Wellington City Proposed District Plan

Hearing Stream 4 – Waterfront Zone

Section 42A Report of the Resource Management Act 1991

REPORT FOR:	Independent Hearings Commissioners
SUBJECT:	Wellington City Proposed District Plan – Hearing Stream 4 – Waterfront Zone
PREPARED BY:	Andrew Wharton
REPORT DATED:	26 May 2023
DATE OF HEARING:	22 June 2023

Figure 1: New Waterfront Public Open Space specific control north of Bell Gully building

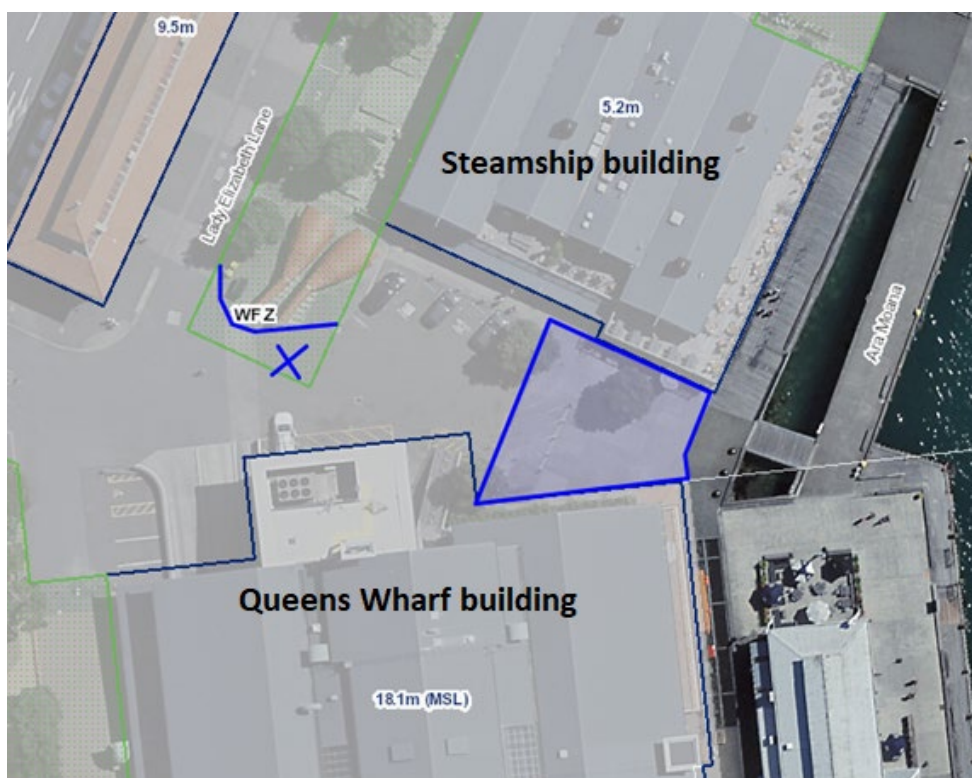
- a. The small public space on the north end of the new Bell Gully building (40 Lady Elizabeth Lane). This was not identified in the Plan as public open space because the land had not yet been converted into publicly accessible space. Now that the building is complete and the public open space developed (refer Figure 1), I support mapping this small area with the Public Open Space specific control. This is consistent with the Public Open Space specific control facing it south of the PWC building.

- b. The small public space between the northern Queens Wharf building and the Steamship Building. This area is currently used as a public space with gardens, seating and bollards to stop vehicle entry. It has a similar function to the area between the Steamship Building and the Meridian Building, which is already mapped as Public Open Space. I support mapping this area with the Public Open Space specific control, along with mapping more accurately the public space around the adjacent public toilets. Refer Figure 2.

54. HS4-WFZ-Rec1: That submission points relating to the Waterfront Zone chapter and its spatial layers in the Plan Maps are accepted/rejected as detailed in Appendix B.
55. HS4-WFZ-Rec2: That the Public Open Space specific control be amended in the Plan Maps to include the areas outlined in bright blue and blue shading in Figures 1 and 2.

Figure 3: Comparison of the Waterfront Zone (in grey) and the sea walls (in bright blue)

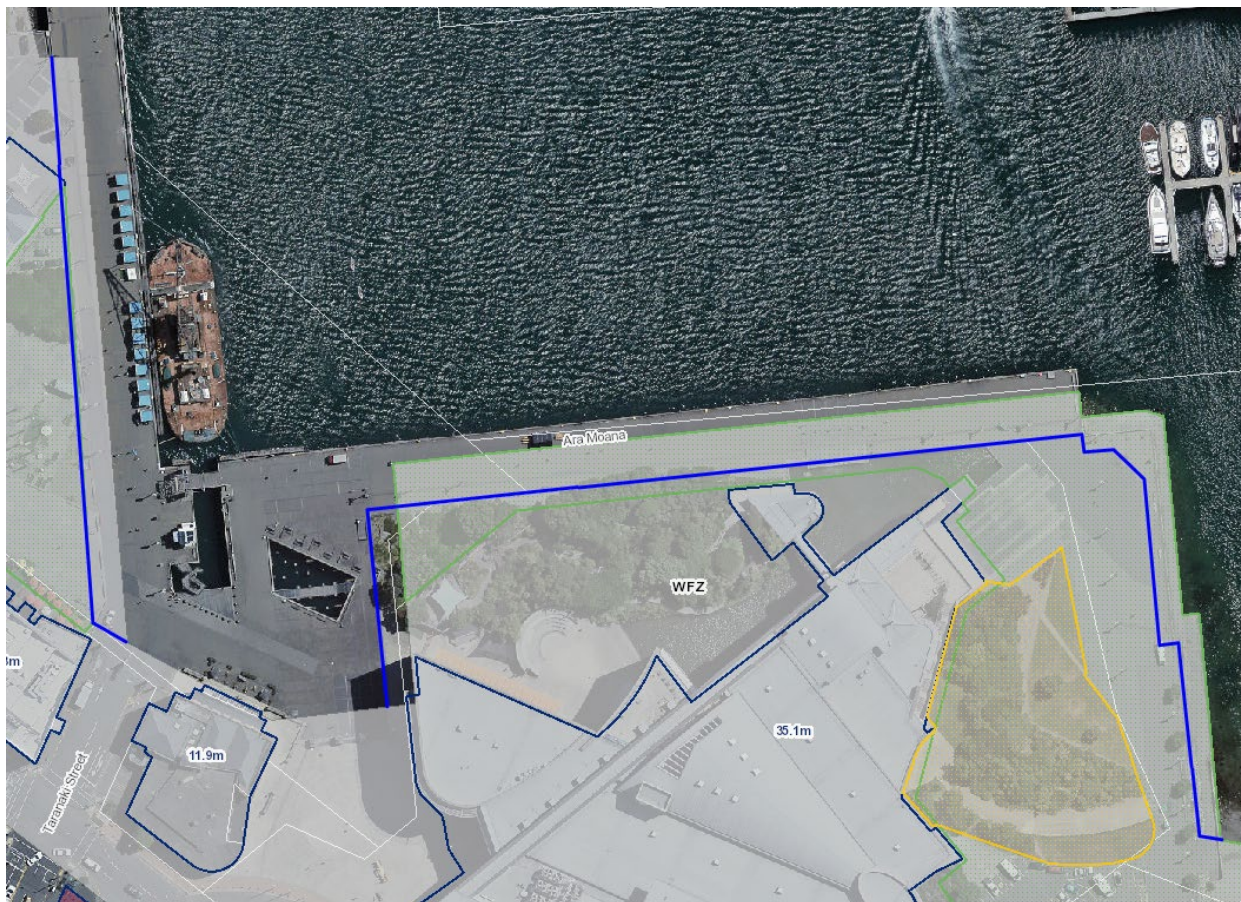
167. **Align Plan map layers with coastal rock revetments in the Waterfront Zone – not yet amended.** While investigating open spaces not covered by the Public Open Space specific control, I found that the Plan’s spatial layers’ boundaries at mean high water springs could be better aligned with the precast concrete and rock revetment walls where the coastal marine area begins. The solid wharves here makes it difficult to locate mean high water springs without an under-wharf survey.

168. Figure 3 below indicates with thicker blue lines the location of seawalls between Whairepo Lagoon and Waitangi Park. These lines are drawn from the seawall asset assessments in 2010 by Cardno and Tonkin & Taylor, and their review in 2020.⁶ Seawalls are a better identification of mean high water springs (and the boundary of district plan jurisdiction) in this part of the City than some of the existing Waterfront Zone boundaries. An example of this is shown in Figure 3.

169. I was not able to get the GIS lines and metadata for the seawalls and the survey methodology before this Section 42A report was circulated. I will provide the Panel with

an updated map when this is available, likely before the hearings begin for Stream 4.
